DOCKETED	
Docket Number:	23-OPT-01
Project Title:	Fountain Wind Project
TN #:	248309-2
Document Title:	response to 2018-2019 raptor survey questions
Description:	N/A
Filer:	Caitlin Barns
Organization:	Stantec Consulting Services, Inc.
Submitter Role:	Applicant Consultant
Submission Date:	1/4/2023 11:30:38 AM
Docketed Date:	1/4/2023

TECHNICAL MEMORANDUM

RE: Request for clarifications on 2017 and 2018 Raptor Nest Survey Reports for the Fountain Wind Project

Figure 1. Flight tracks for the March 20, 2017 aerial raptor nest survey at the Fountain Wind Project.

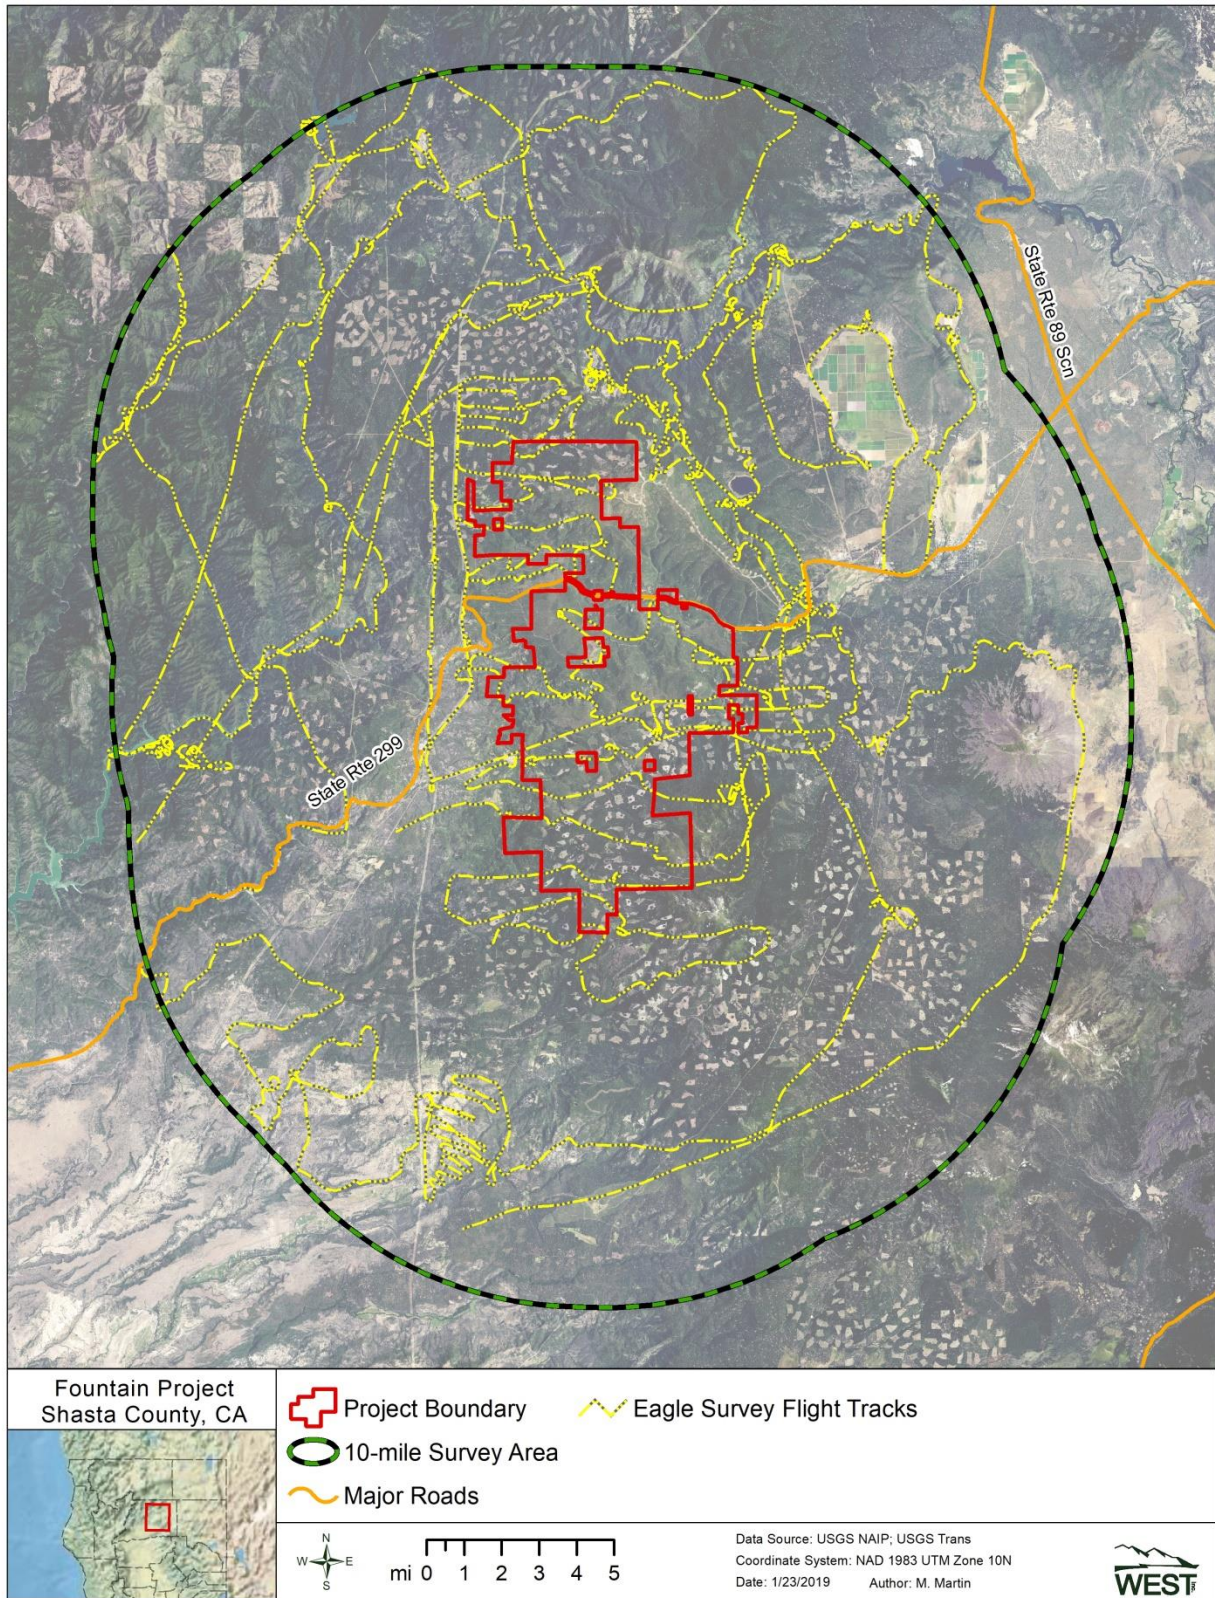
- 1. The 2017 report described the helicopter survey methods as "intuitive controlled survey method that focused on identifying and searching specific habitat features within the Survey Areas that held the highest potential to support the target species". In general, this approach is appropriate. However, the report does not describe in greater detail where the survey was conducted within the survey area or the proportion of the survey area that was actually covered by the survey. Information in the reports is limited to the locations of occupied nests. Presumably, there are large areas within the 10-mile survey area that do not contain 'high potential habitat features' and therefore were not surveyed according to the helicopter protocol described. The extent of survey coverage is important in assessing overall habitat conditions in the survey area (see below). Please be more specific about which areas within the survey area were determined to contain "high potential habitat features" and therefore were surveyed pursuant to the described protocol.*

Flight tracks for the 2017 aerial survey are provided in Figure 1. During the survey, the 10-mile buffer survey area was visually subdivided into sections delineated by prominent landscape

features (e.g., powerline corridor, major drainages and ridgelines, roads). All portions of the 10-mile survey area were covered with each section flown via meandering transects. Using an intuitive controlled survey methodology, areas within each subdivided section identified as having potentially suitable substrates (e.g., cliffs, large/dominate trees, powerlines) to support stick nests of large raptors (e.g., eagles, large buteos, osprey) were more thoroughly surveyed, while areas without suitable substrates for such species were not further investigated.

Figure 2. Location of historical bald and golden eagle nests within 10 miles of the Fountain Wind Project. Data provided by the California Natural Diversity Database (CNDDDB; 2017) and the California Department of Fish and Wildlife (CDFW; C. Battistone, pers. comm.).

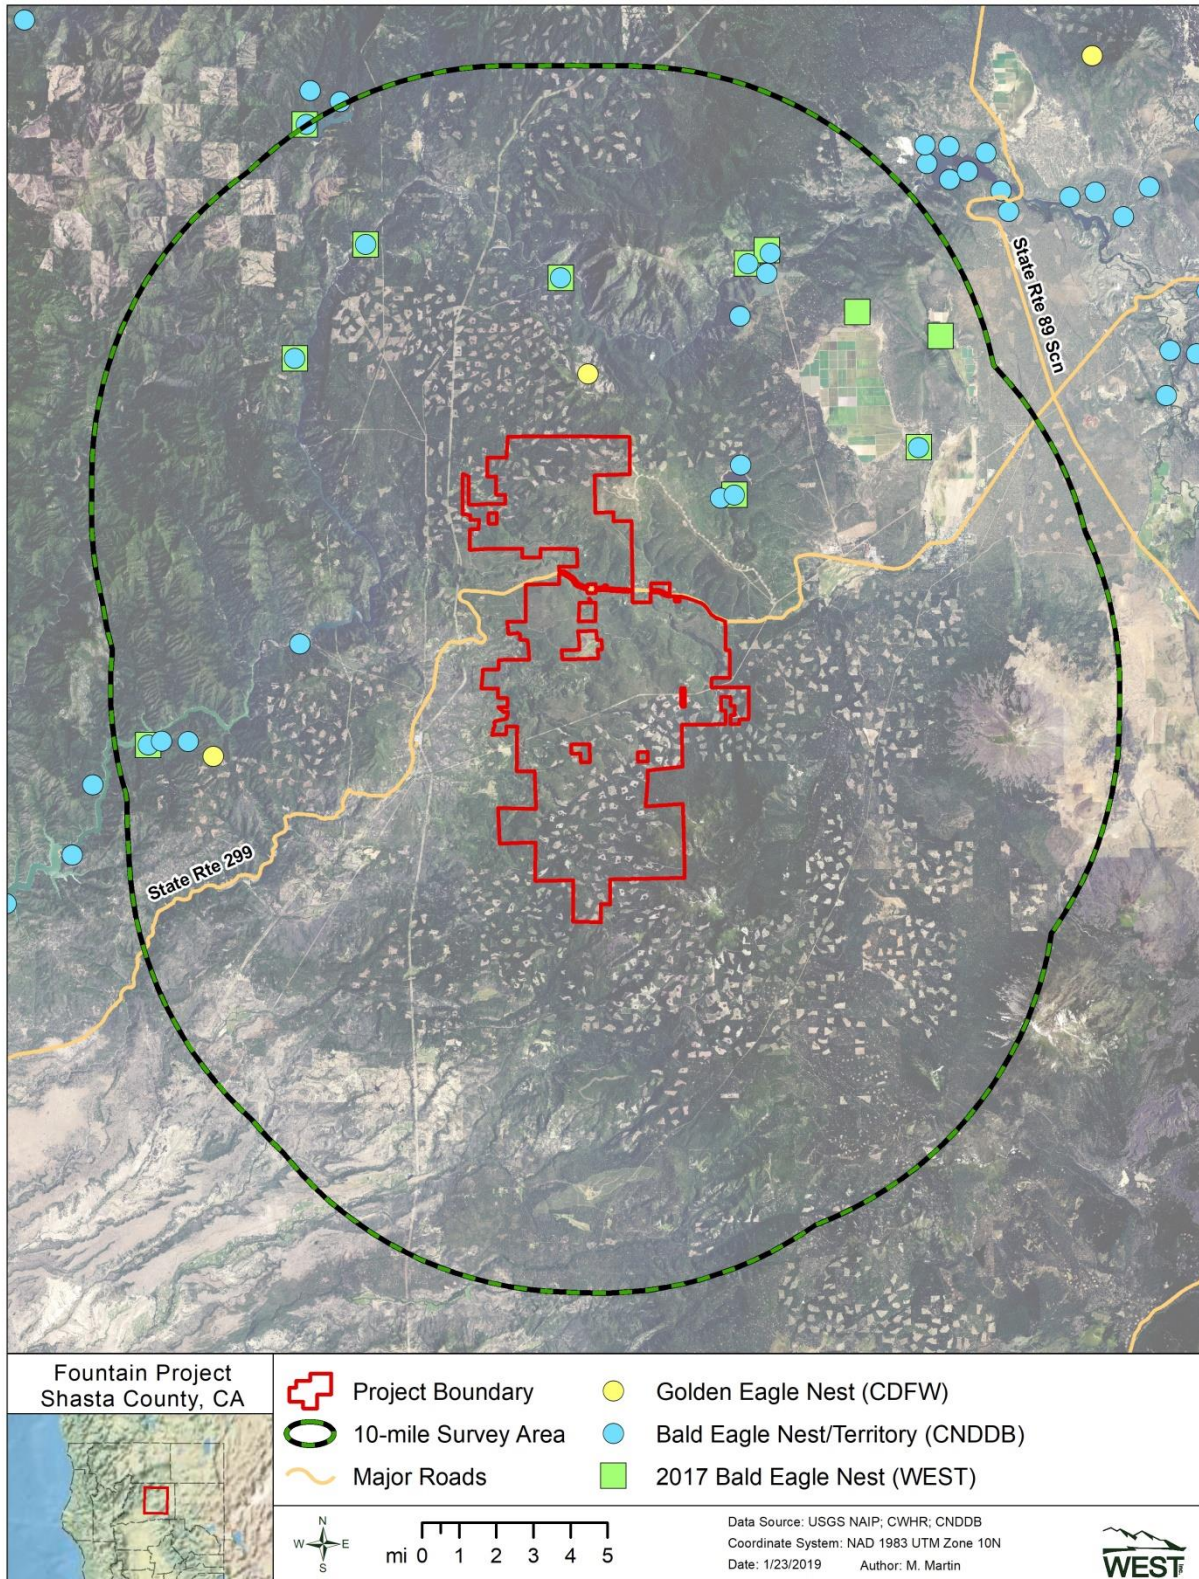
3. *Although none were found during the survey, it would be helpful if the occurrence maps provided the location of historic golden eagle nest locations provided to them by the CDFW – and inactive historic bald eagle locations within the survey area. The 2017-2018 surveys provide information limited to the current nesting distribution. Including historic locations would be useful in presenting a more thorough characterization of the eagle nesting population in the area and would inform trend reporting as part of the cumulative effects analysis. Please include historic locations on the occurrence maps included in the 2018 report.*

The location of historic bald and golden eagle nests, as provided by the California Natural Diversity Database (CNDDDB) and CDFW, are provided in Figure 2. Two historic golden eagle nests and 17 historic bald eagle nests have been documented within the 10-mile buffer survey area (Figure 2). Based on information provided by the CDFW, the northern historic golden eagle nest was observed during an aerial survey in 1979; no other information was provided. The historic golden eagle nest in the west of the survey area was observed in a conifer during a ground-based survey in May 1985, at which time it was determined to be occupied and active. Both of these historic golden eagle nest locations, and the immediately surrounding area, were searched extensively during the March and May, 2017 aerial surveys; however, no nest structures were identified suggesting these nests are no longer present. Of the 17 historic bald eagle nests identified by CDFW/CNDDDB, 11 were located by WEST during the 2017 aerial survey with nine of those found to be occupied and active.

Figure 3. Land ownership within the Fountain Wind Project and surrounding area (PVT = Private, USFS = US Forest Service, BLM = Bureau of Land Management, ST = State, BIA = Bureau of Indian Affairs, USBR = US Bureau of Reclamation).

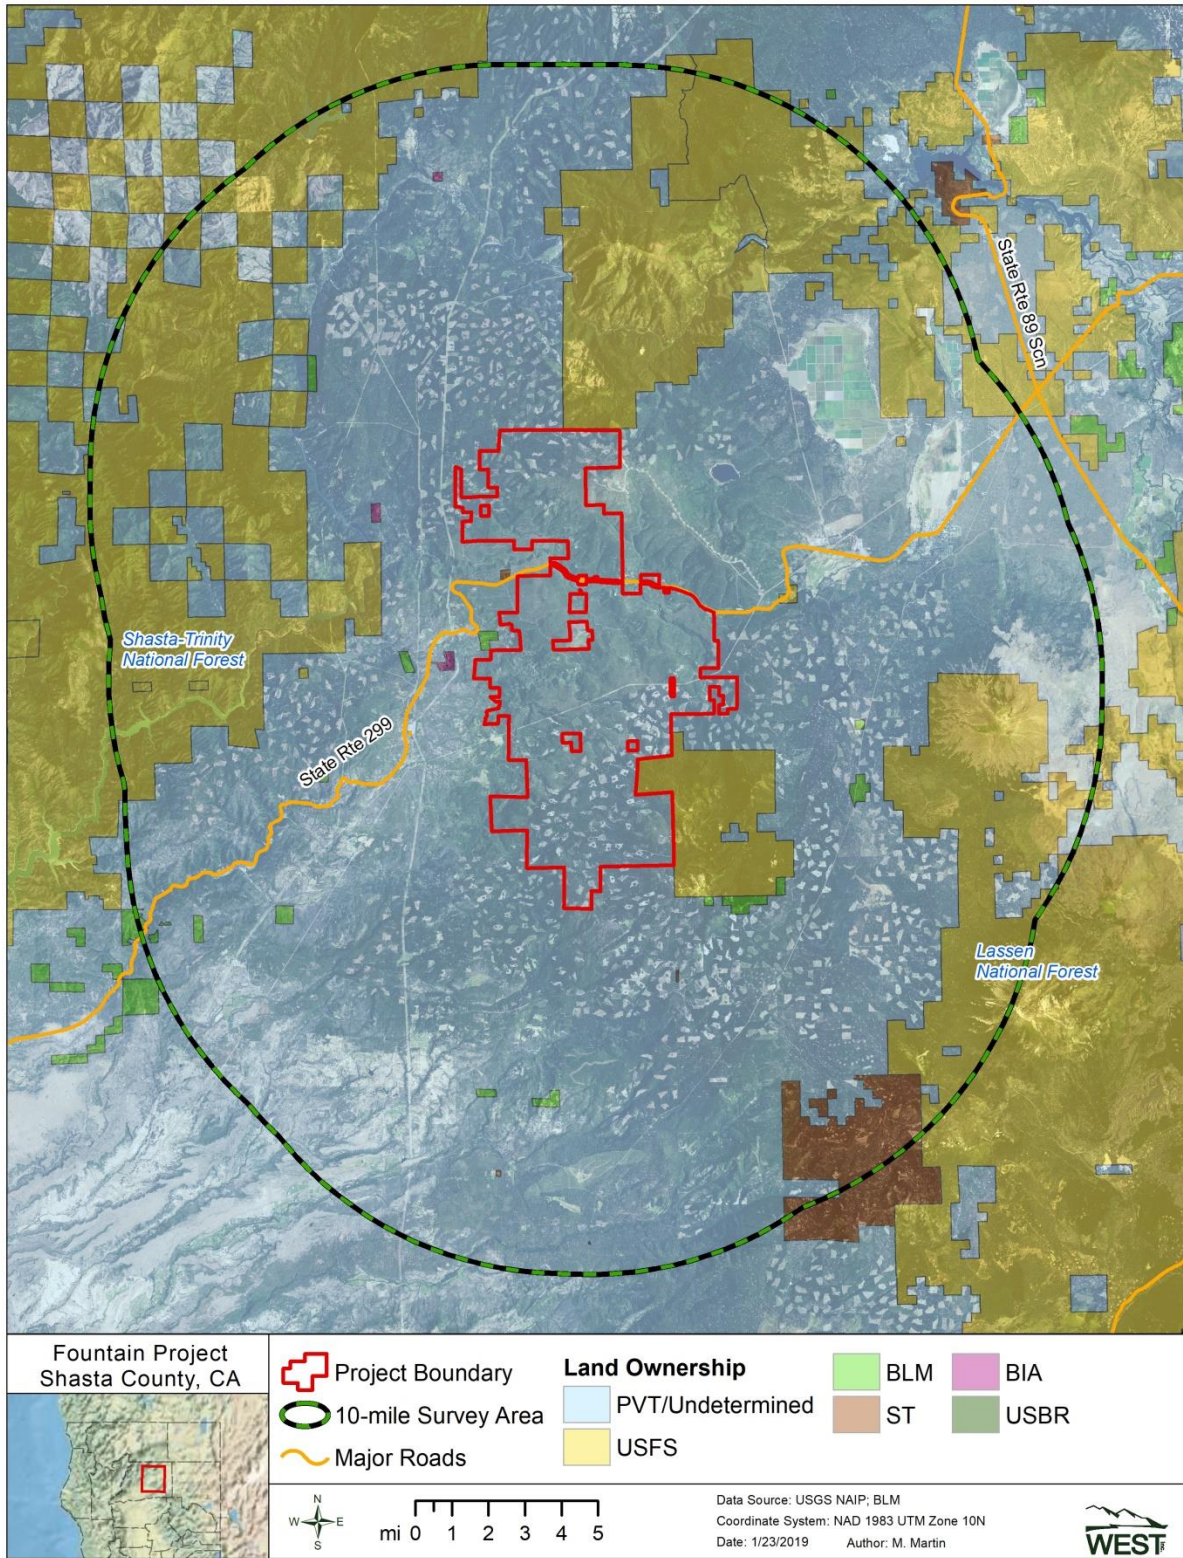
4. *The legend on Figure 1 is missing information on land ownership. The light green and white areas, some or all of which is presumably private land, should be labeled in the legend. Confirmation of this would be useful in assessing land ownership within the 10-mile survey area relative to the current nesting distribution and how this influences land management practices and potential suitability for nesting eagles. Please provide the requested land ownership information.*

The requested land ownership information is provided in Figure 3 below. WEST was not able to locate publicly available data for individual private landowners within the 10-mile buffer survey area; however, the vast majority of land is owned by private timber companies with smaller areas possibly owned by utility companies and private individuals. In publicly available datasets reviewed, these areas were labeled as “undetermined” and are included in the private/undermined category in Figure 3.
